Access Compliance Report Public Rights-of-Way (Curb Ramps)

Main Street: DORRANCE_DR Cross Street: DORRANCE_DR Location: S

ADA ID: RPRK211202120623 Ramp Type: Type 1 - Perpendicular Initial Pass/Fail: Fail Overall Compliance: No Severity Score: 15

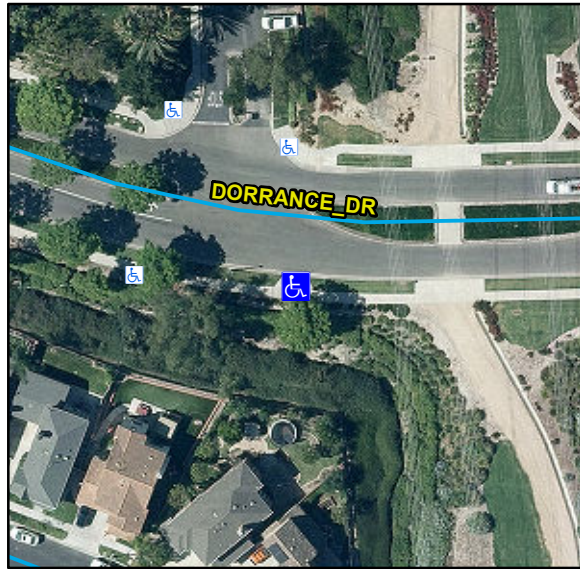
R204.3, R304.2.2, STD 1115

Remove & Replace Entire Ramp.
